ALERT SERVICE BULLETIN

407-21-123

MODEL AFFECTED: 407

SUBJECT: TAILBOOM ASSEMBLY, NEW AIRWORTHINESS LIMITATION SCHEDULE (ALS) INSPECTION REQUIREMENT.

Figure 1 – Location of Identification Data Plate and Modification Identification Data Plate, Tailboom Assembly

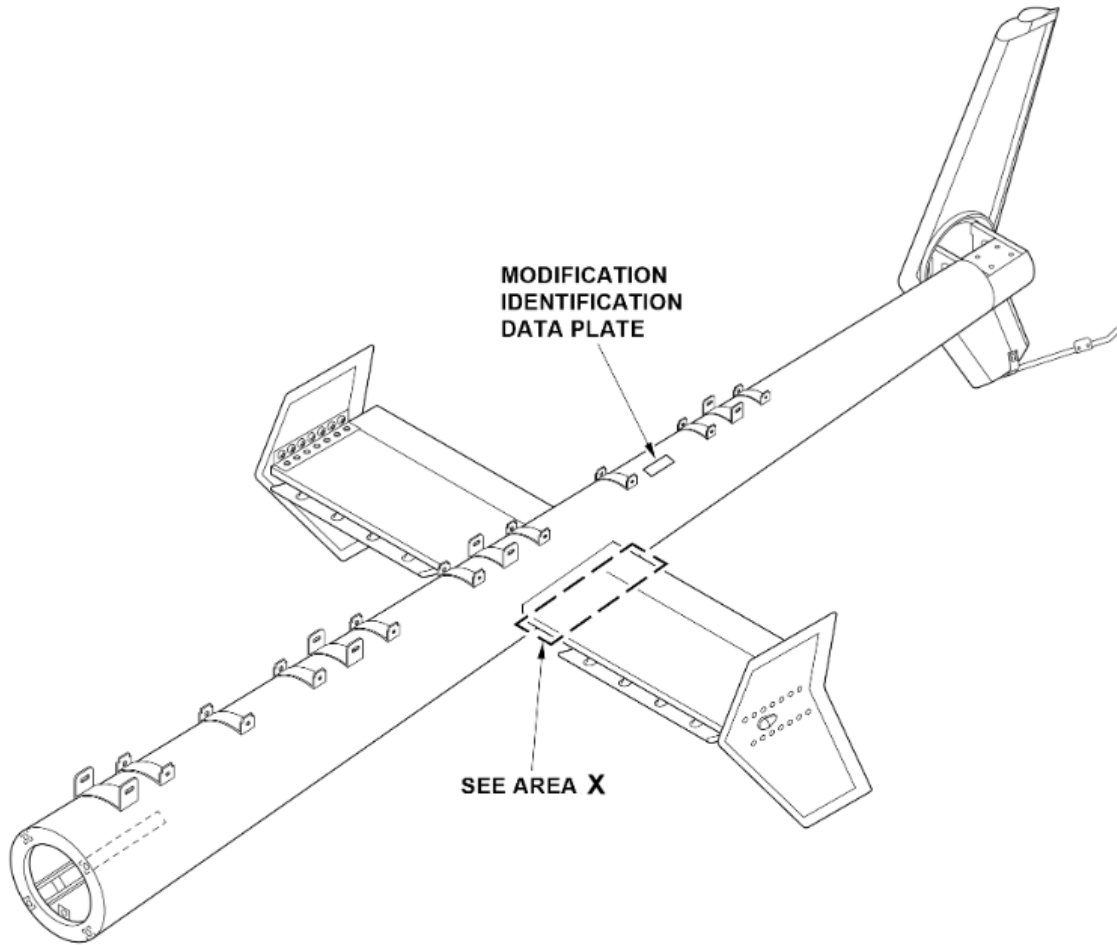
1. Verify the helicopter historical service records to determine the part number of tailboom assembly installed. The tailboom assembly part number can also be confirmed by removing the aft tail rotor driveshaft cover (DMC-407-A-53-04-00-05A-520A-A) and looking at the identification data plate located near Boom Station (BS) 129 (Figure 1).

If the tailboom assembly has been modified from its original configuration, the part number on the identification data plate may have been re-identified, or the part number of the current configuration may be identified on a modification identification data plate which will be located near Boom Station (BS) 129 (Figure 1).

Figure 2 – Inspection Area on Tailboom Assembly (Sheet 1 of 3)

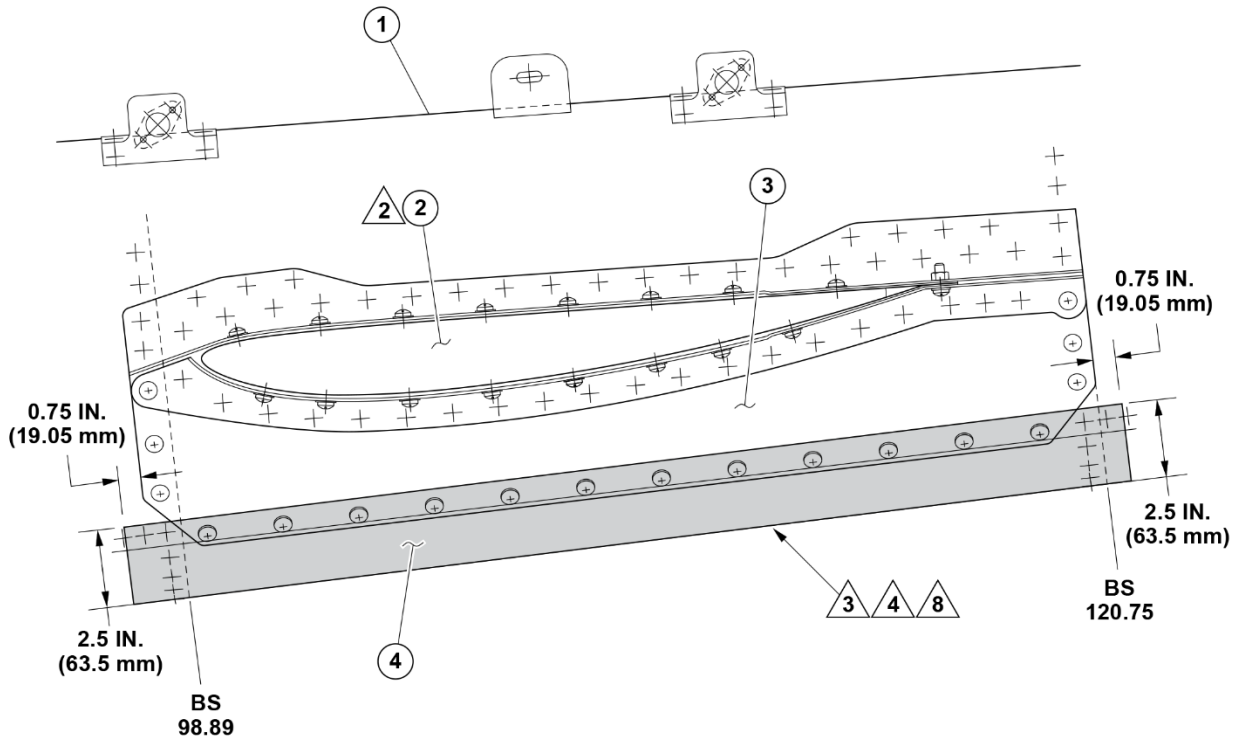
- b. Using a 10X magnifying glass and bright light source, carry out a DVI of the tailboom assembly skins for cracks just below the edge of mating horizontal stabilizer lower attachment support (Figure 2, Area X).

- (b) Using a 10X magnifying glass and bright light source carry out a DVI of the tailboom assembly skins that are located under the closure plate for any cracks (Figure 2, Area X).

- (1) If a crack is found on the tailboom skins, replace the tailboom assembly with a serviceable tailboom assembly that meets the intent of this ASB prior to next flight, and report findings to Bell Product Support Engineering (productsupport@bellflight.com). Go to step 4.

- (2) If no crack is found on the tailboom assembly skins, but a crack is found on the lower left closure plate, do the following:
 - (a) Remove cracked lower left closure plate and discard (DMC-407-A-53-02-00-00A-921A-A). The closure plate is considered unserviceable.

1. If no cracks are found, install a serviceable lower left closure plate (DMC-407-A-53-02-00-00A-921A-A) and go to step 4.
 2. If a crack is detected, replace the tailboom assembly with a serviceable tailboom assembly that meets the intent of this ASB.
